Subject: Class 1 Permit Modification Notifications, Waste Isolation Pilot Plant Hazardous Waste Facility Permit Number: NM4890139088-TSDF

**Class 1 Permit Modification Notifications**

**Waste Isolation Pilot Plant  
Carlsbad, New Mexico**

**WIPP Permit Number - NM4890139088-TSDF**

Figure D-1  
WIPP Surface Structures

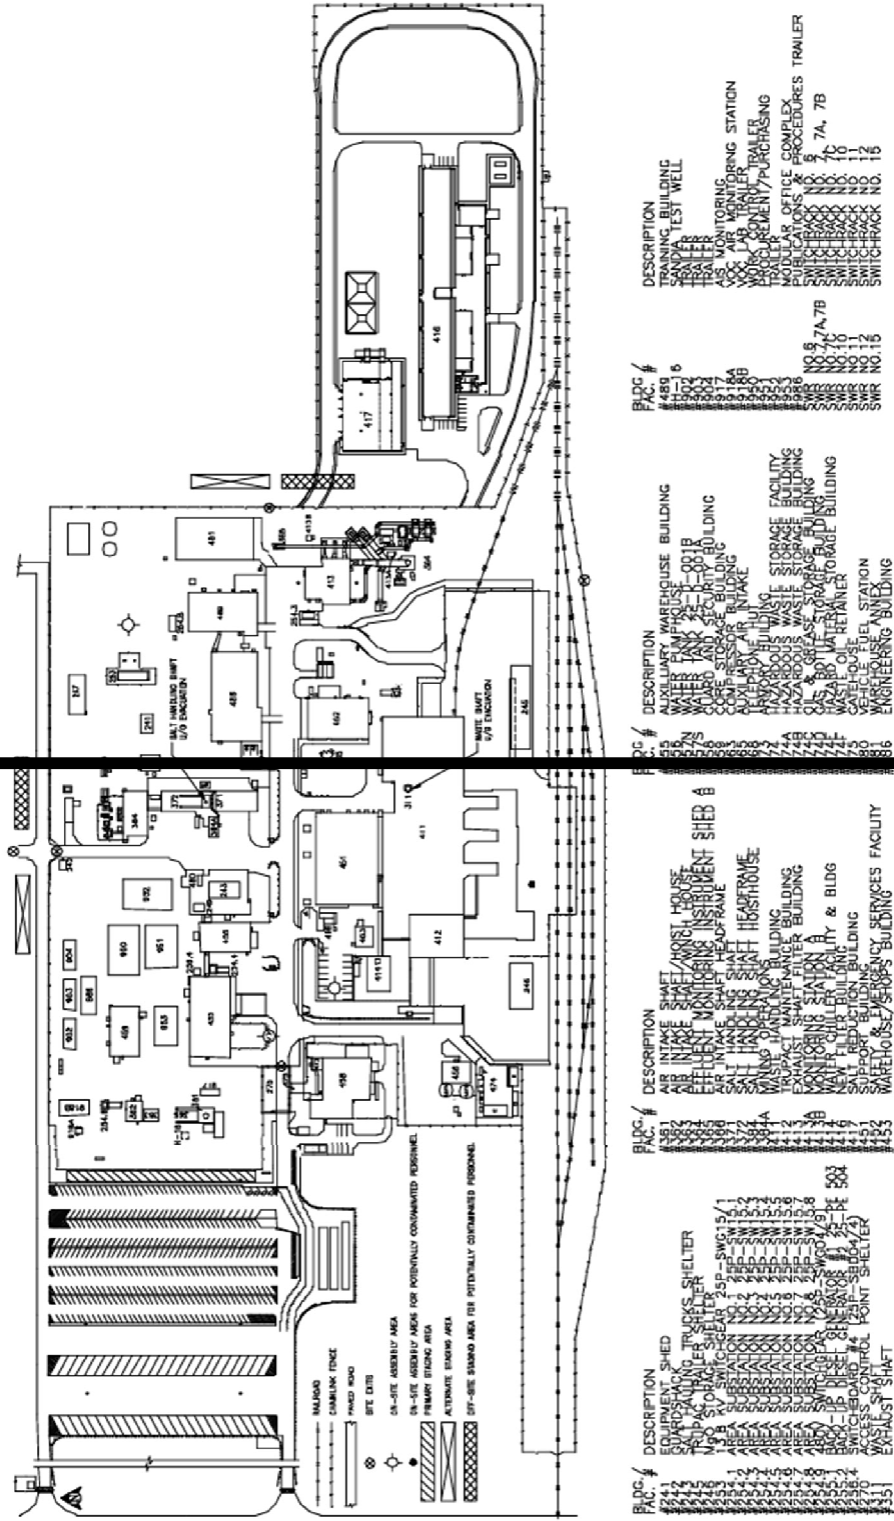
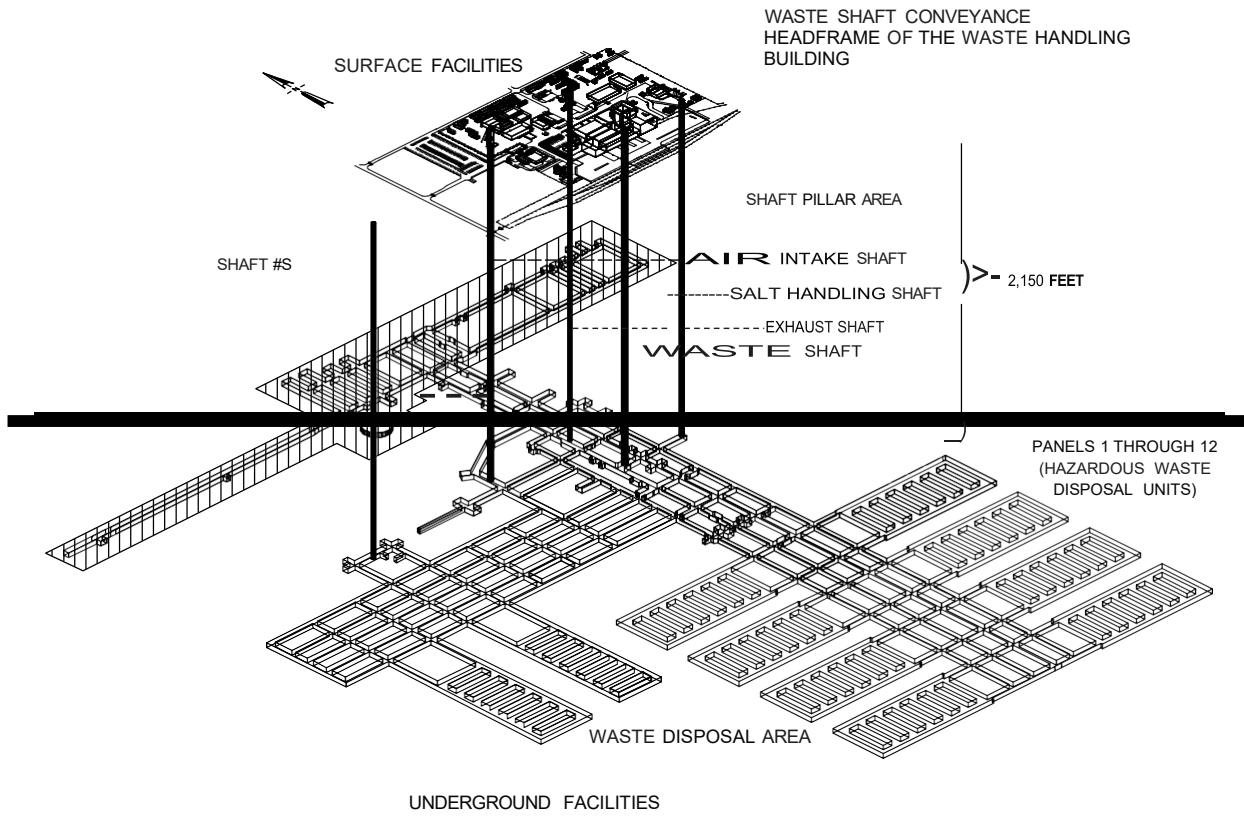
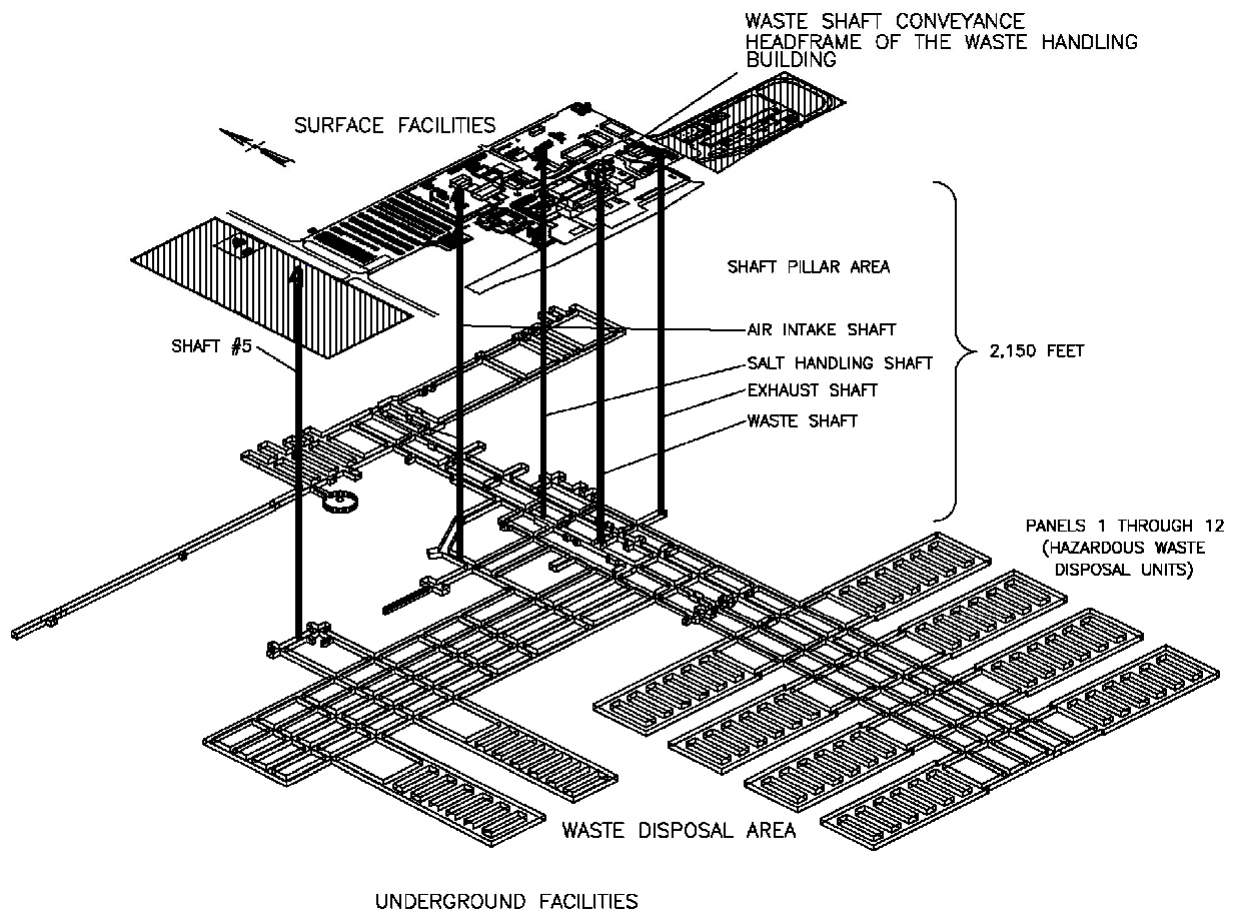
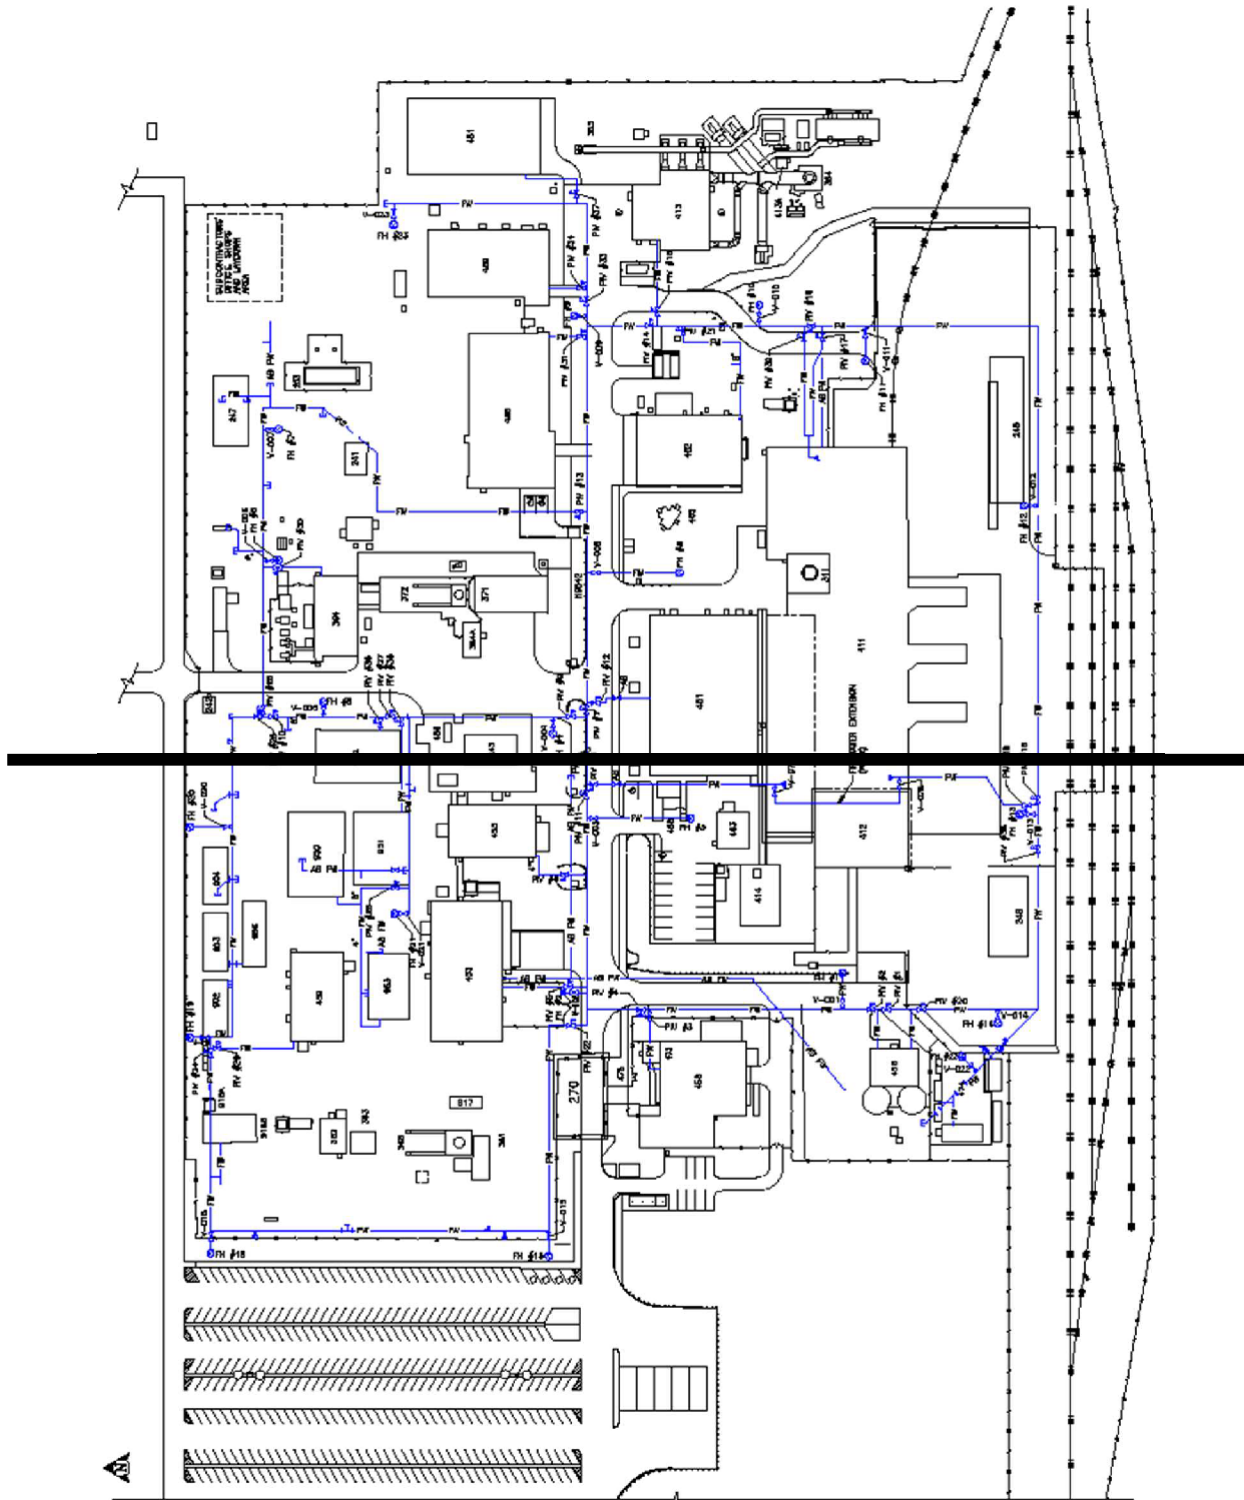
- Figure D-1, *WIPP Surface Structures*
    - Updated figure with the new fire water pump house (Building 490) and storage tanks (Tanks 491E and 491W) located in the north east corner of the PPA, removed the rail tracks, moved the northeast and southeast fence lines, updated the parking lot layout, modified label for gate markers, added gate markers, added an additional assembly area for potentially contaminated personnel, moved the existing assembly area for potentially contaminated personnel to the south, and added the north and south access road designations. Made other updates to the buildings and structures to ensure consistency with other figures in the Permit that show the surface structures and to ensure consistency with the current layout of the facility. Information from Figure D-1-NFB was moved to this figure and the Shaft #5 area was added. Shading has been added over areas that are currently under construction (i.e., Shaft #5 and the SSCVS).

Permit Attachment D, Figure D-1, has been replaced with a figure that includes the Shaft #5 and SSCVS areas and Figure D-1-NFB has been removed since this information is now shown in Figure D-1. Permit Attachment M, Figure M-58, has been replaced with a figure that includes the Shaft #5 and SSCVS areas and Permit Attachment M, Figure M-59, has been removed since this information is now shown in Figure M-58. In addition, Permit Attachment D, Figures D-1, D-4, D-4-NFB, and Permit Attachment M, Figure M-58, have been updated to ensure consistency with the current layout of the WIPP facility and consistency between figures. For example, the new fire water pump house (Building 490) and tanks (Tanks 491E and 491W) have been added, the rail tracks have been removed, the parking lot configuration has been updated, and the southeast fence line has been moved to reflect the current layout at the facility. Other updates to these figures have been made to ensure they are consistent with each other (e.g., labeling, line placement, marker placement, etc.). These changes are needed to update the Permit with the current layout of the facility and to streamline figures.

**Figure D-2**  
**Spatial View of the WIPP Facility**

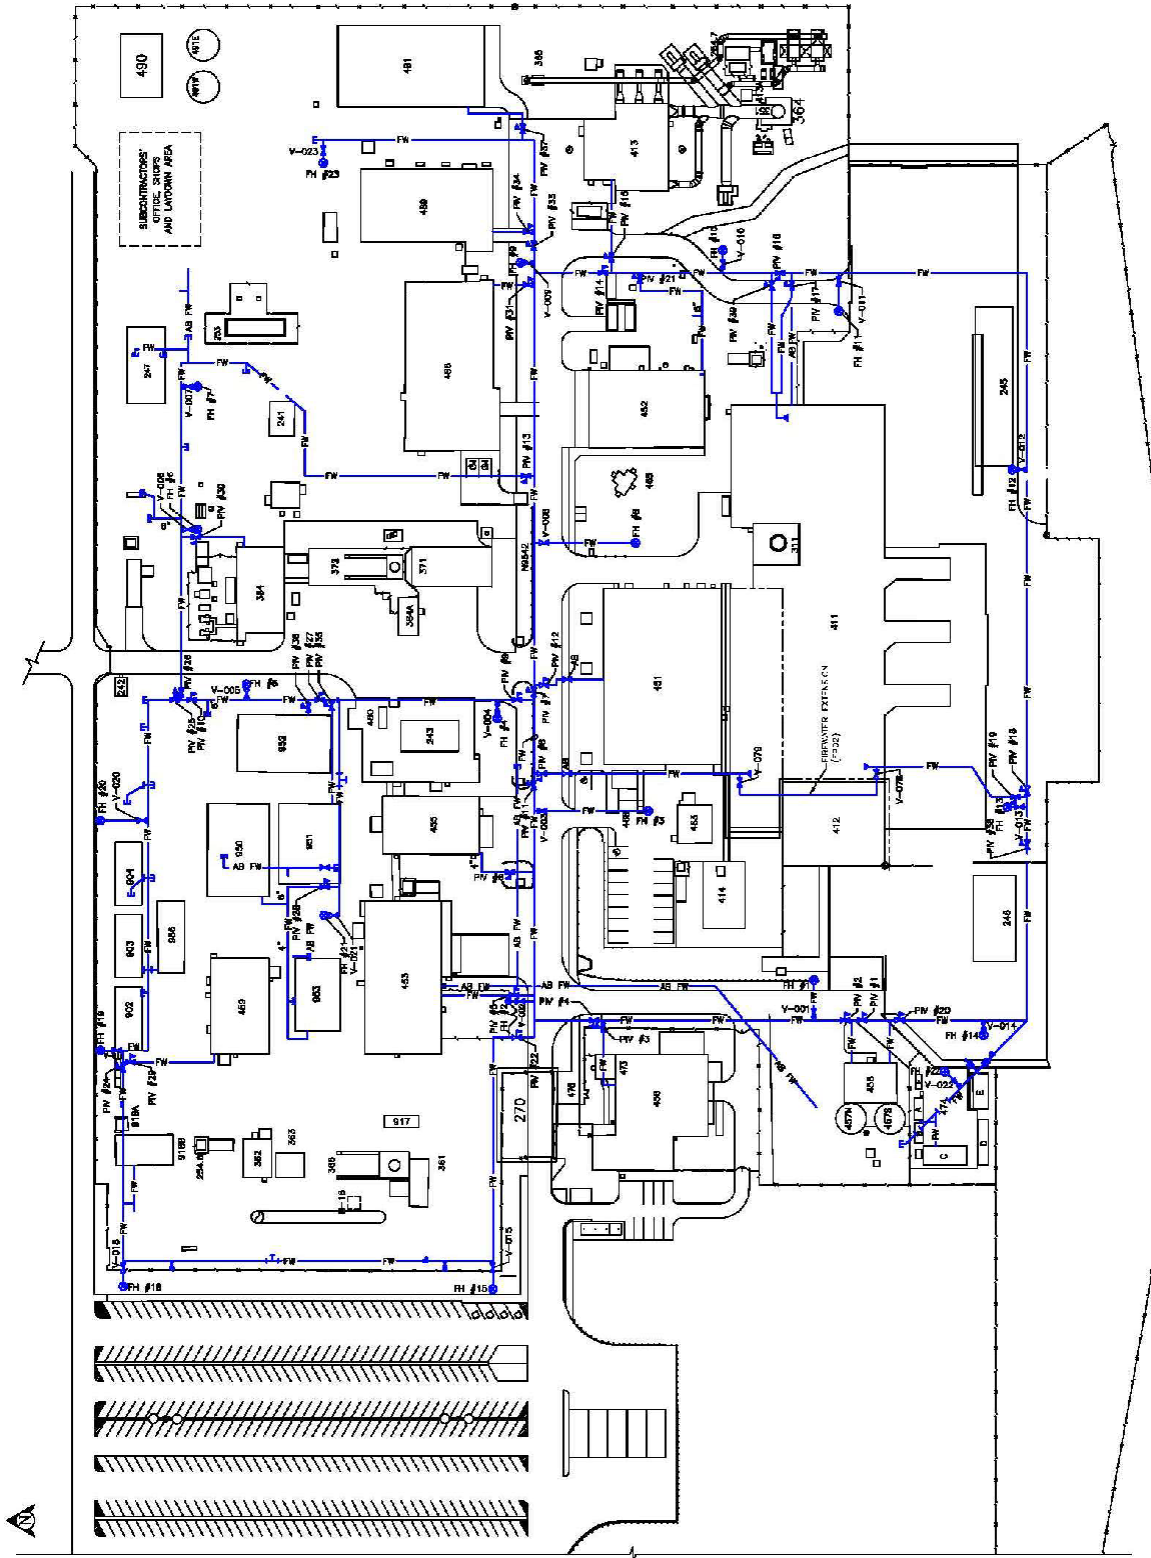
- Figure D-1-NFB, *WIPP Surface Structures with Building 416*
    - Deleted figure.
  - Figure D-2, *Spatial View of the WIPP Facility*
    - Updated figure with the Shaft #5 and the SSCVS. Made other updates to the building and structures to ensure consistency with other figures in the Permit that show the surface structures and to ensure consistency with the current layout of the facility.

Permit Attachment B, Figure B3-1, Permit Attachment D, Figure D-2, and Permit Attachment M, Figure M-44, have been replaced with a figure that includes the Shaft #5 and SSCVS areas and updated other areas to ensure consistency with other figures that depict the surface and underground facilities and ensure consistency with the current layout of the facility.

Figure D-4  
Fire-Water Distribution System

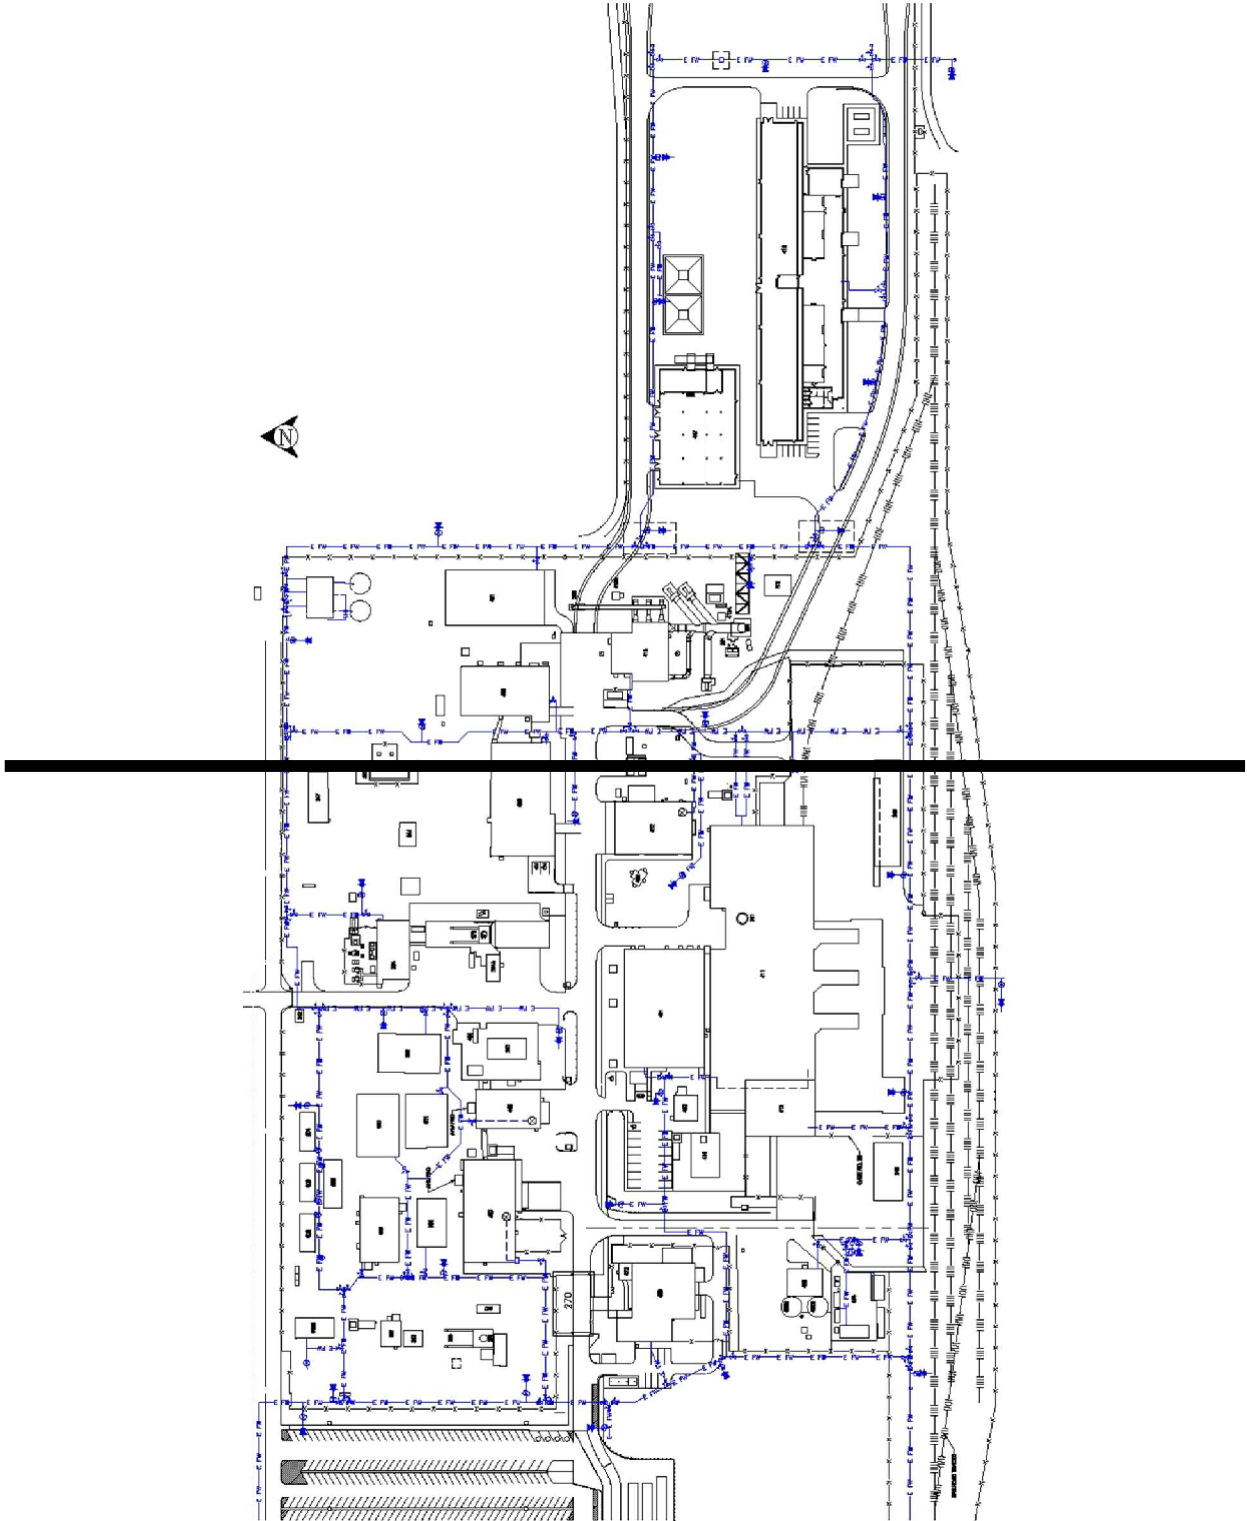
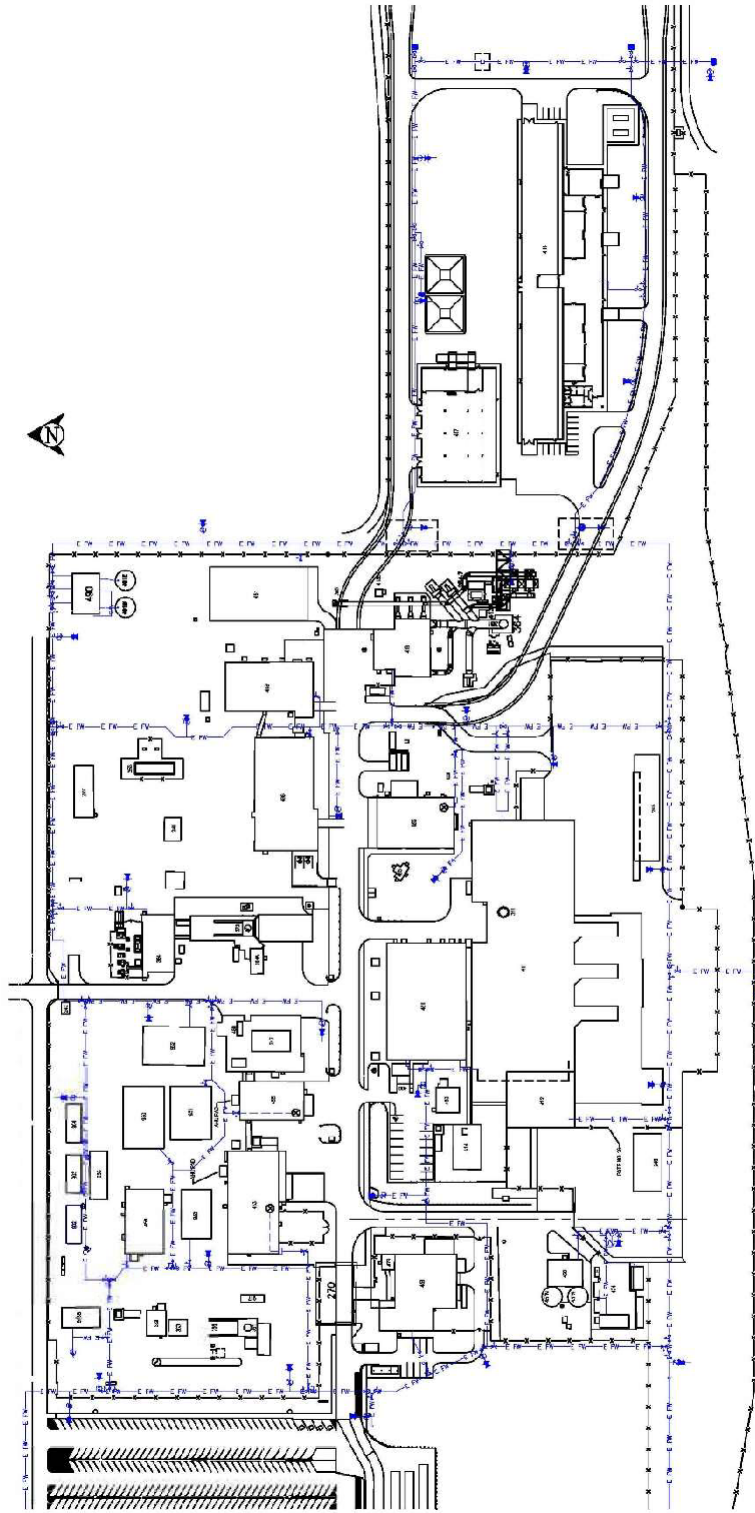
- Figure D-4, *Fire-Water Distribution System*
    - Updated figure with the new fire water pump house (Building 490) and storage tanks (Tanks 491E and 491W) located in the northeast corner of the PPA, removed the rail tracks, moved the northeast and southeast fence lines. Made other updates to the buildings and structures to ensure consistency with other figures in the Permit that show the surface structures and to ensure consistency with the current layout of the facility.
